LINOTYPE IMPROVEMENT INFORMATION SHEET

NO. 257

LOOSE PULLEY FOR TAKING UP SLACK OF MATRIX DELIVERY BELT

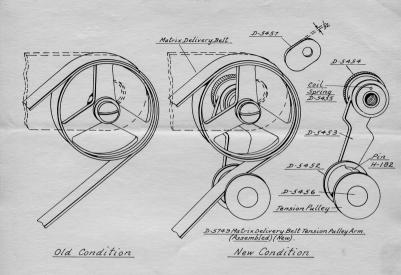
A loose pulley construction has been designed for the purpose of maintaining a uniform tension on the matrix delivery belt. This will eliminate a loose belt with attendant possibility of transposition, if the operator does not use the manual method of tightening the belt as provided.

Can be applied to outstanding machines by discarding present washer D-107 and Nut E-165. Add D-5454, D-5455, D-5749. For outstanding machines with auxiliary magazines proceed the same as designated above and substitute D-5457. See Mailing Sheet #489.
